APPLICATION NO: 23/4152M

LOCATION: The Dam Embankment of Poynton Pool Reservoir,
Poynton Park, London Road North (B5092), Poynton

REPRESENTATIONS

Option 1C Section

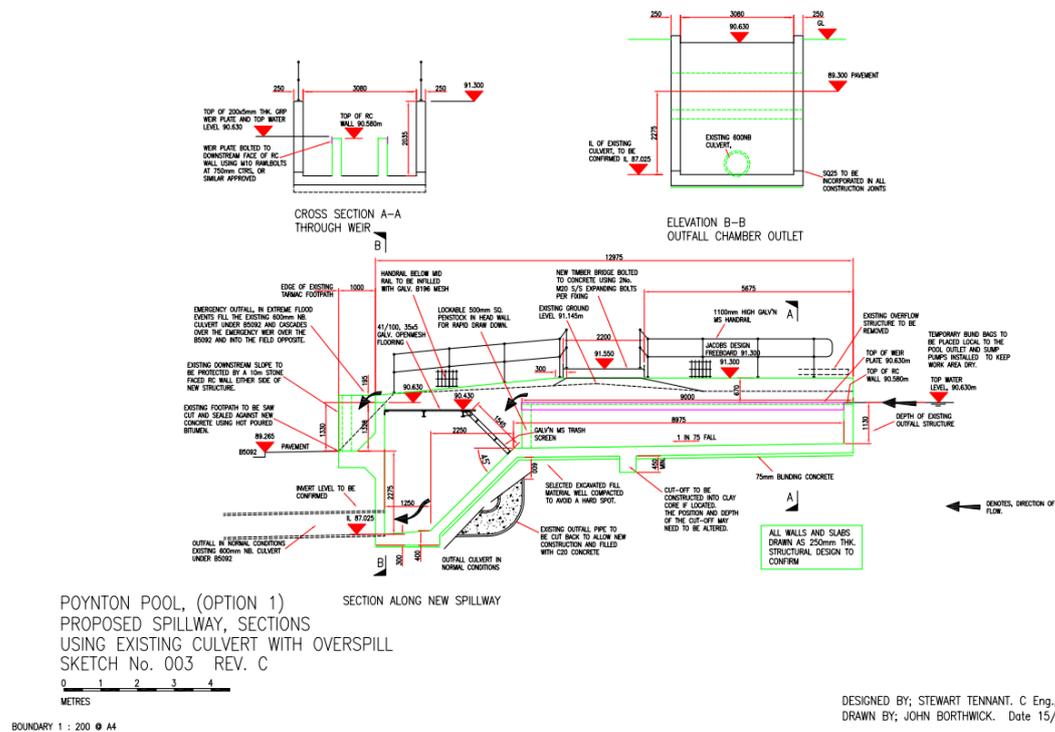
The proposed solution is a conventional reinforced concrete spillway built on the line of the existing overflow structure and culvert. It is a double-sided weir and has been designed to pass the design floods calculated by CEC's technical advisors. There are two options. In Option 1C, the emergency outfall is onto the B5092 as with the application proposal. Option 2C proposes two 1200mm diameter pipes beneath the B5092 to accommodate normal flow and extreme flood events.

It is stated that the required minor increase in freeboard can be achieved by the careful addition of more earth of the same composition as the existing embankment, to be re-vegetated naturally, without any significant impacts on trees.
